Technical Note

To: Whom it May Concern
From: Richard Manock
Subject: Home Farm, Llay – Crown Crossroads Improvements
Ref: 065665-CUR-00-XX-RP-D-72001-V00
Date: 26 June 2019

- 1.1 This technical note has been prepared to provide a narrative to support approval of the suggested improvements to the Crown Crossroads signalised junction indicated on drawing '065665-CUR-ZZ-XX-DR-D-9562-C02 Crown Crossroads MOVA Signal Design' (*Annex A*).

Annex D

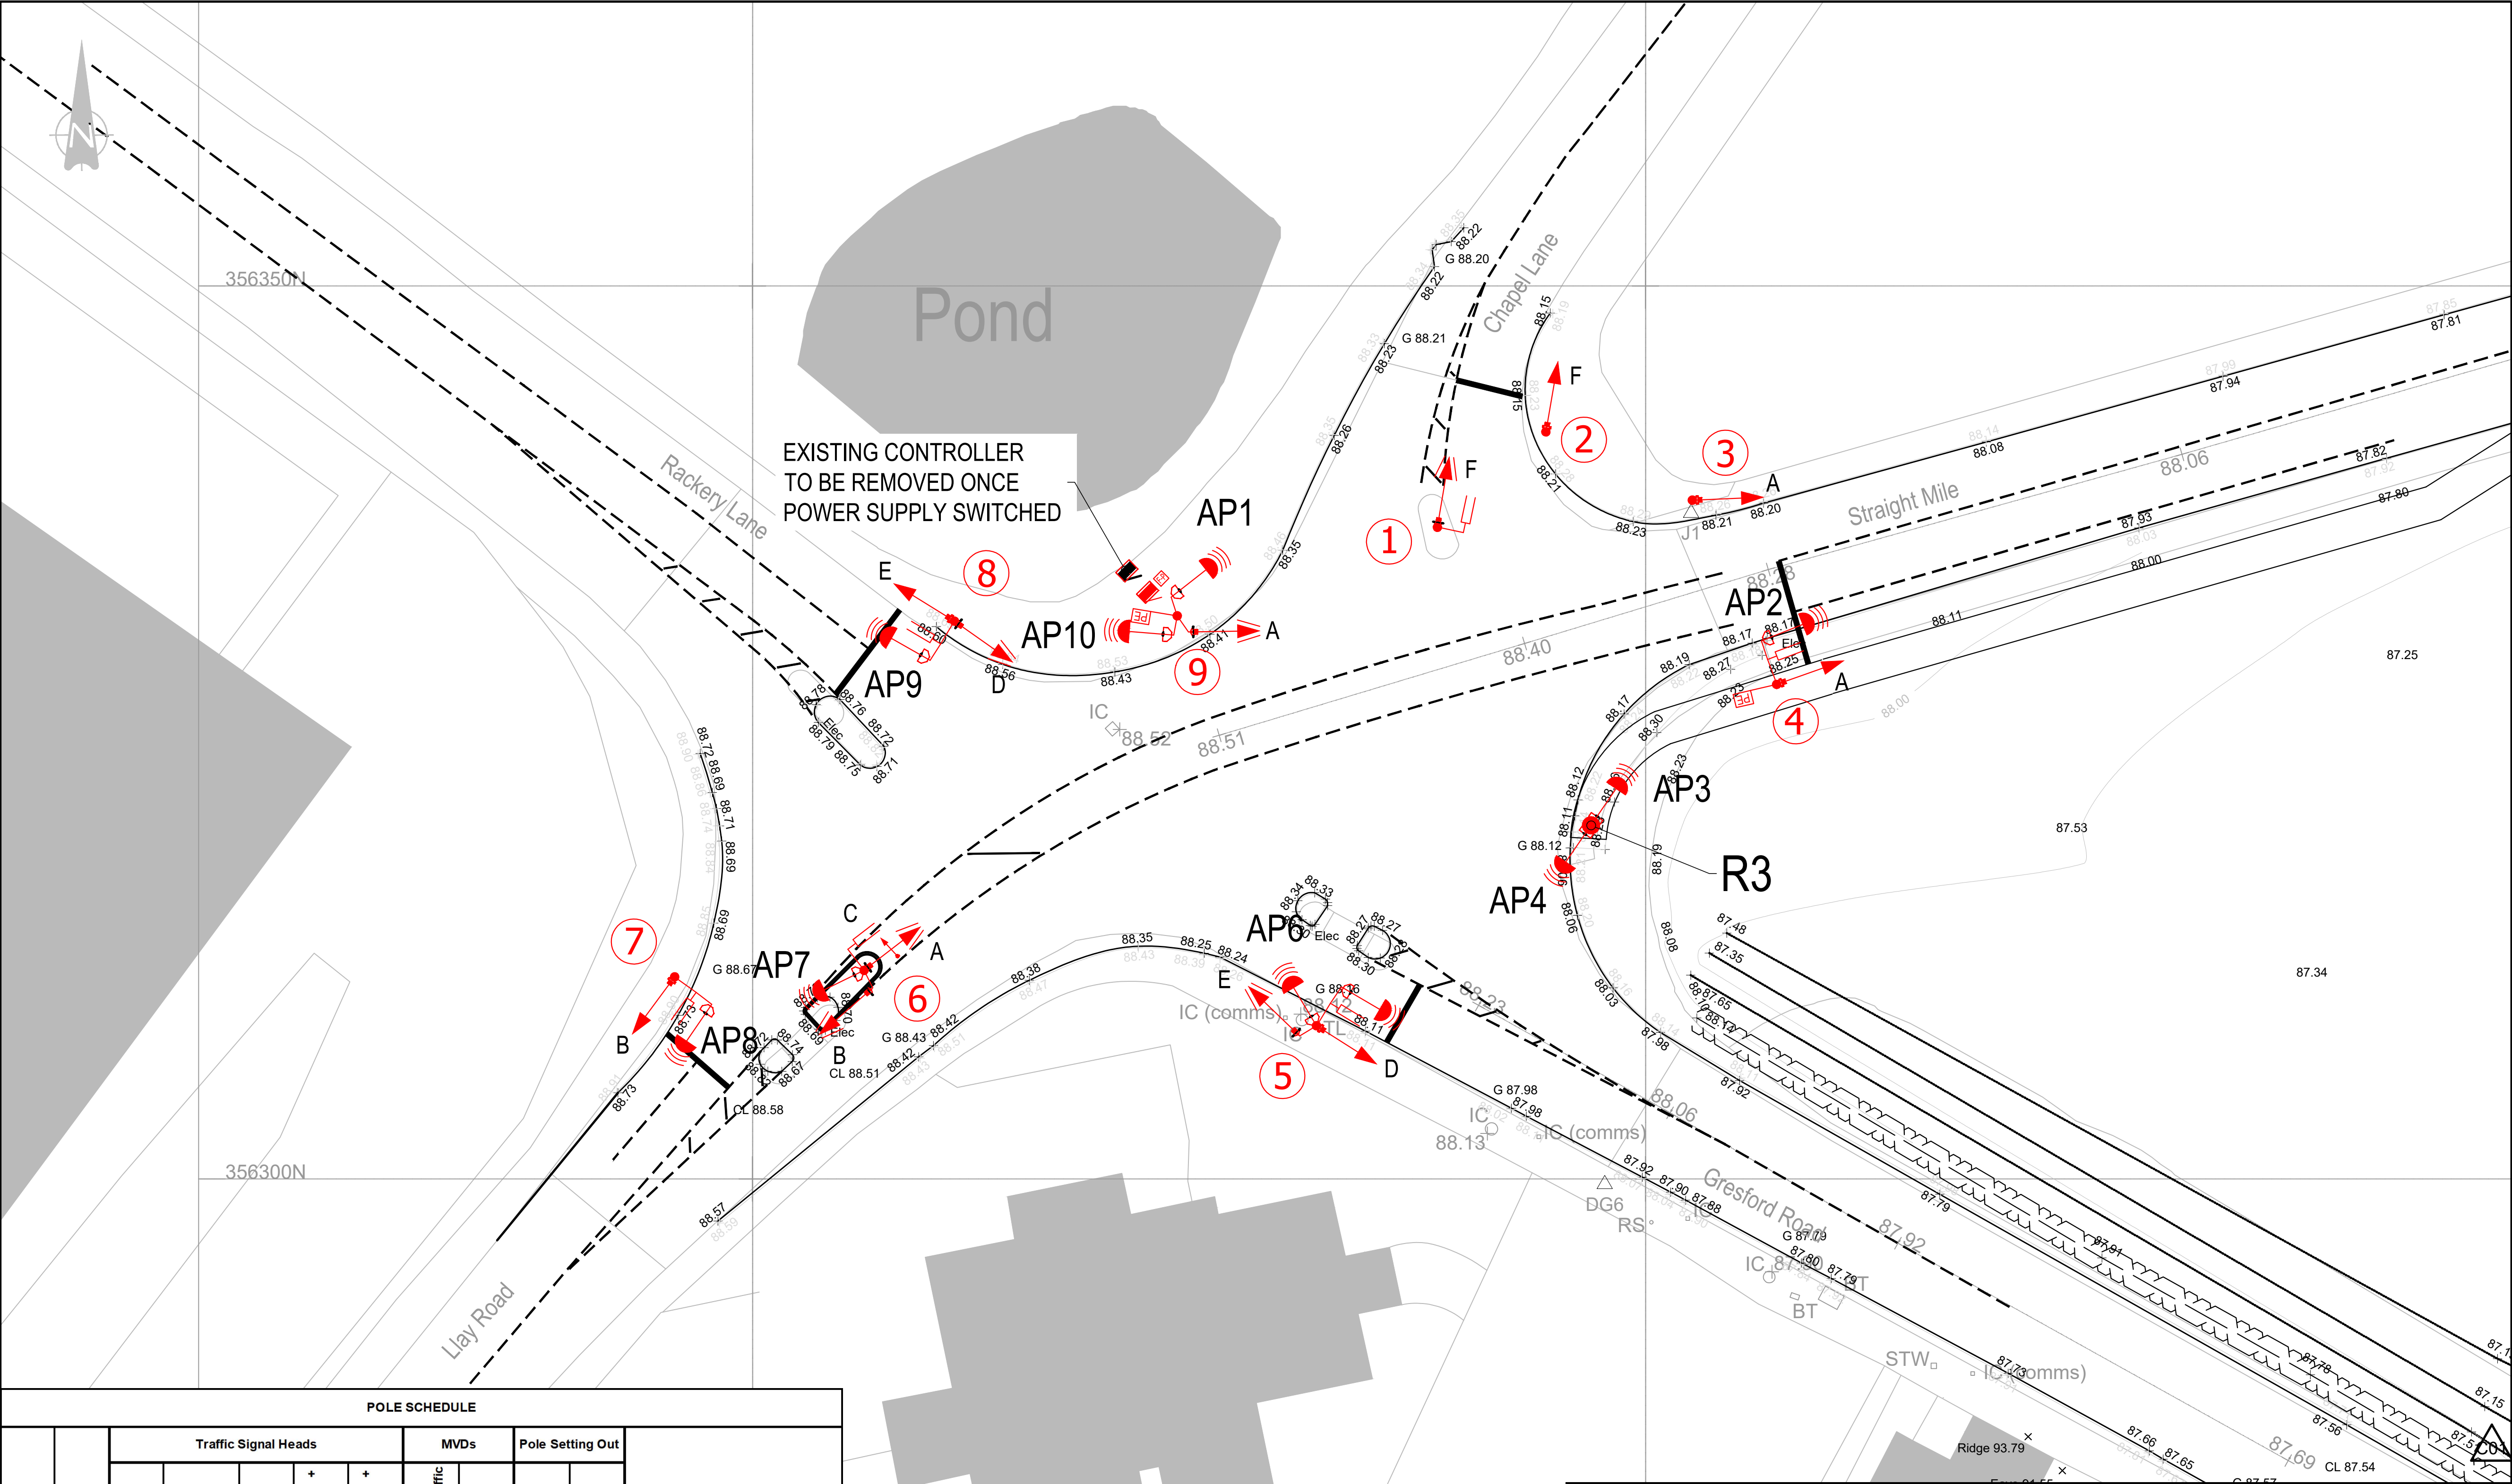
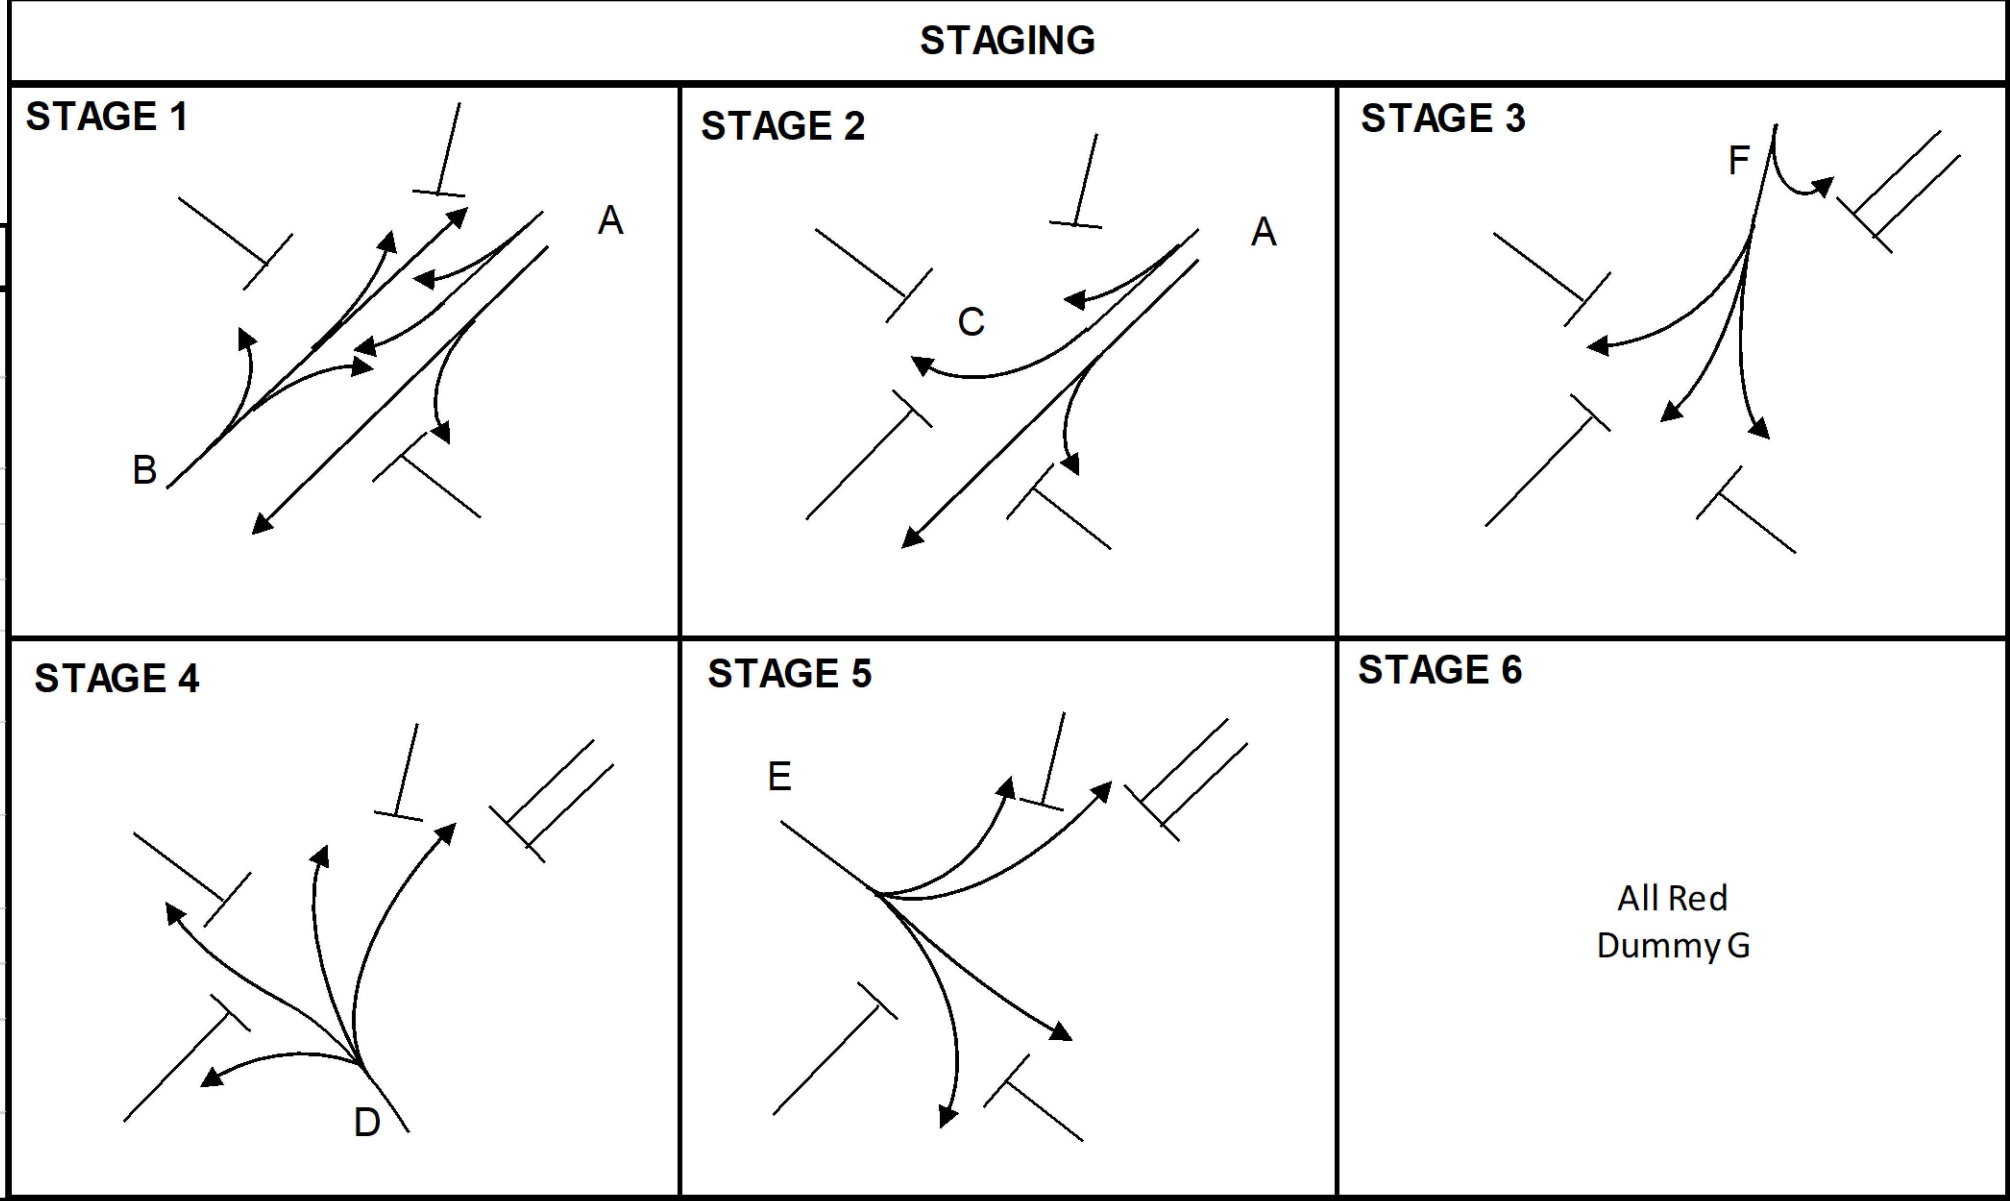
- 1.5 The proposals for improvements agreed at planning approval are as shown on drawing '065665-CUR-ZZ-XX-DR-D-9562-C01 Crown Crossroads MOVA Signal Design' (*Annex D*).

- 1.6 Linsig modelling of this proposal for 2026 with development (*Annex E*) suggested that degrees of saturation of 104.5% and 98.8% would be achieved for the AM and PM peaks respectively, providing the required betterment on a 2026 base flow "do nothing scenario".

Problem Identified (Paragraph No)	Problem Accepted (YES/NO)	Recommendation Accepted (YES/NO)	Action (describe)
CROWN CROSSROADS			
9.3.1 Location: Within traffic signal junction Problem Summary: Proposed right-turn road markings and signal staging may increase risk of vehicular collisions The proposed dedicated right-turn road markings within the junction for Straight Mile traffic turning into Chapel Lane and Rackery Lane, combined with the signal staging, meaning right-turning traffic must give way to oncoming vehicles from Llay Road, may increase the risk of vehicular collisions within the junction. Vehicles wishing to turn right from Straight Mile must wait in the same right-turn lane for both Chapel Lane and Rackery Lane resulting in an increased risk of rear-end shunt collisions. For example, a following vehicle wishing to turn right into Rackery Lane may not realise the vehicle in front is turning into Chapel Lane. There is also a risk that a vehicle waiting to turn right into Chapel Lane may cause a following vehicle wishing to turn into Rackery Lane to try and undertake, thus entering the straight ahead/left turn lane on Straight Mile, resulting in side-swipe type collisions. Additionally, a group of vehicles or a larger vehicle wishing to turn right into Gresford Road from Llay Road will be unable to fit into the right-turn pocket within the junction and will back-up into the ahead/right-turn lane from Llay Road, increasing the risk of rear-end shunt collisions. There is also a risk that these vehicles waiting to turn right into Gresford Road may cause a following vehicle wishing to travel straight on onto Straight Mile to try and undertake, thus entering the left turn lane on Llay Road, resulting in side-swipe type collisions.	Y	Y	Staging to be reviewed. Design to be amended.

Problem Identified (Paragraph No)	Problem Accepted (YES/NO)	Recommendation Accepted (YES/NO)	Action (describe)
Recommendation The signal staging should be amended so that the Straight Mile and Llay Road arms have their own stage, as per all other arms on the junction, negating the need for right turning vehicles to give way to oncoming traffic.

9.3.2 Location: Llay Road approach to traffic signal junction Problem Summary: Narrow lane width may result in side-swipe type collisions The drawings show two lanes are to be provided on the Llay Road approach to the proposed traffic signal junction, however the carriageway width at this location does not appear wide enough for two lanes. Vehicles attempting to enter the junction in two lanes may overhang into the adjacent lane increasing the risk of side-swipe type collisions. (Photo 13.3) Recommendation The carriageway should be widened to provide adequate width for two lanes on the Llay Road approach to the junction.	Y	Y	Staging to be reviewed. Design to be amended.

9.4.1 Location: Throughout the traffic signal junction Problem Summary: Lack of facilities for pedestrians It was observed during the site visit that there is a lack of facilities for pedestrians throughout the traffic signal junction. It is unclear how the adjacent development will tie-into the junction with regards to pedestrian movement. If there is an increase in pedestrian demand throughout the junction, the lack of appropriate facilities may increase	Y	P	This is acknowledged as an existing problem but there is limited scope within the adopted highway boundary to improve fully. It is proposed that uncontrolled crossings will be provided across Straight Mile (east of the lane widening), Gresford Road (south of signal stop line) and Llay Road (either at splitter island or west of signal stop line). This will enable pedestrians to access all routes within the limitations of the junction geometry. Design to be amended.
